**Upper and Lower Wrangell Dams  
Seismic Safety Report  
Wrangell Alaska**

Upper and Lower Wrangell Dams - Seismic Stability Report		Review Comments / Responses	
Comments by Charlie Cobb		15-Mar-06	
Comments by Charlie Cobb		Response:	
1	Please include a soil legend or make consistent with USCS terminology	Gibbons - Logs have been corrected to comply with USCS terminology.	
2	The report initially states that the soil strengths from S&W, 1993 were "appropriate.. for this program", but then uses substantially different values for the static analysis without much discussion in Section and Table 7.1. Some additional detail or reference to the changes may be warranted	Gibbons - See response to Mierzejewski's Comment No. 4.	
3	There was a M6.8 earthquake on the Queen Charlotte Fault on June 28, 2004 not mentioned as a "major" earthquake in Section 5.4 (maybe because its less than 7?).	Harrison - I listed several earthquakes that were very large and felt at Wrangell the list is not comprehensive. I assume there have been many M6 earthquakes on the Queen Charlotte Fault.

Figure 5.1 Earthquake Epicenters in Southeast Alaska

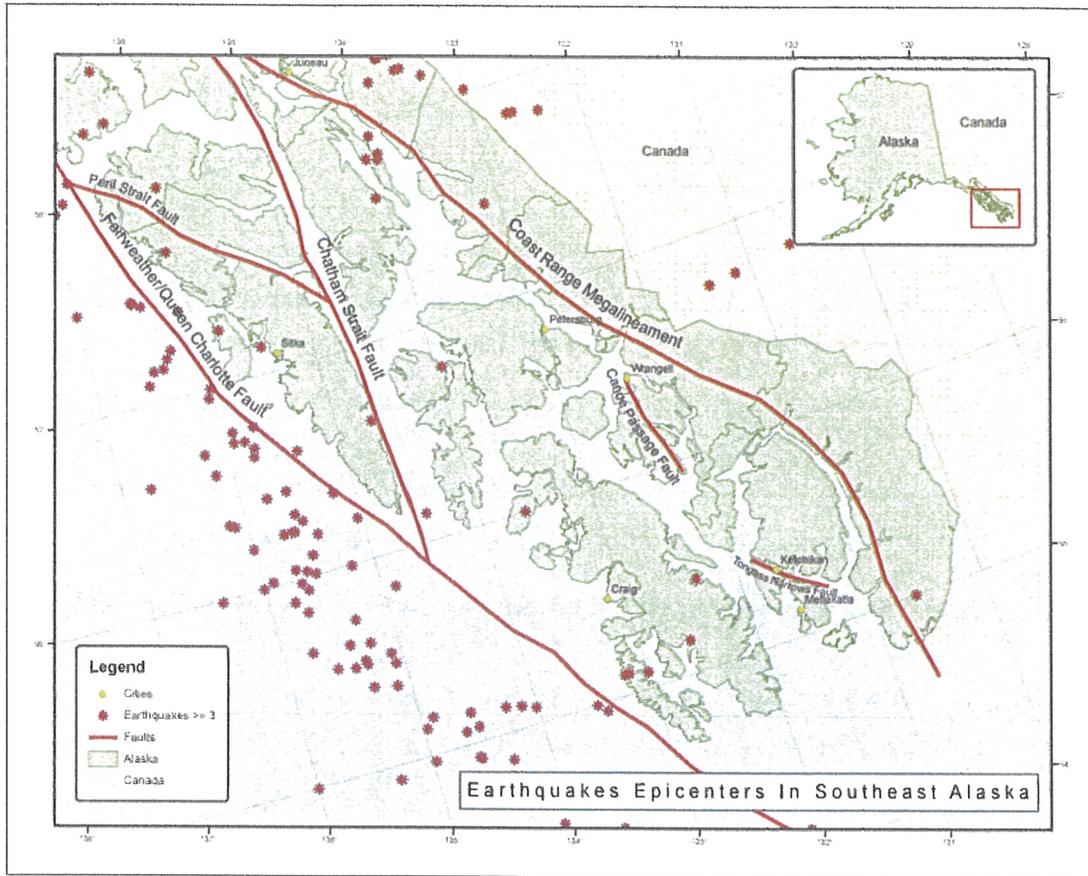
<b>Comments by Marcus Palmer</b>	<b>Response:</b>
1	Section 5.4, paragraph 1 and Section 5.5, paragraph 1 both refer to the "attached plate". I believe that they both refer to figure 5.1. Suggest that both be changed to reference figure 5.1.	Gibbons - Done.
2	On page 18 – fix typo, the 2500 year event should be 2% (not 10%) probability of exceedance in 50 years.	Gibbons - Done.
3	I reviewed your report and the report completed by Shannon and Wilson cited in your report. You addressed briefly the differences in assumptions for earthquake loadings; the loadings you chose are certainly more conservative. This more conservative approach is probably warranted in light of the NEHRP USGS map having very close acceleration contours in the area. ER 1110-2-1806 also states that the MCE is determined from the DSHA (Deterministic Seismic Hazard Analysis) and that the MDE is the same as the MCE for "critical features". It should be clarified if the analysis is performed using the MCE, MDE or if they are the same.	Agreed. In this case the MCE and MDE were considered to be the same. Mr. Cobb also commented on this subject. A further analysis would need to be performed to determine the critical nature and downstream hazards in order to determine if the MDE can be taken as less than the MCE. This would be performed during the feasibility and design phases of the project.
